Product Change Notification

TE Connectivity

Product Change Notification: E-17-012062

End-of-life announcement for Solarlok connector, PN y-1394461-x and y-1394462-x

PV4-S Connector

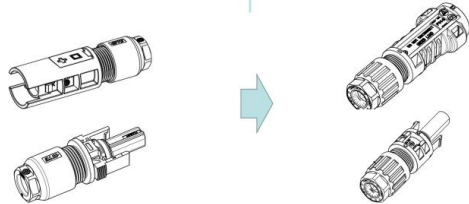
Dear Customer, As you may be aware starting on 11DEC2017 the existing PV connector norm EN 50521 will expire. At that time, all PV connectors will be required to meet the EN 62852 norm. All of the norm changes will result in TE obtaining new TUV certification numbers for our products, however due to extreme limited sales on some product lines and the availability of an alternate and cheaper product we decided that the standard Solarlok connector (known for its plus and minus coded feature on the male as well female part) will go end-of-life as per Dec 2017. As said, alternative products with improved specifications and performance are available and meet the new IEC 62852 norm, called PV4-S.

- TUV ratings per IEC/EN 62852 (R 50372137)
- 35A 1500V for 2.5mm²
- 40A 1500V for 4mm²
- 45A 1500V for 6mm²
- UL ratings per UL 6703 (E 353372)
- 15A 1500V for 14AWG
- 20A 1500V for 12 AWG
- 30A 1500V for 10 AWG
- PN y-2270024-x Male
PN y-2270025-x Female
- Customer drawing 2270024/2270025
- Product Specification 108-137077
- Application Specification 114-137077
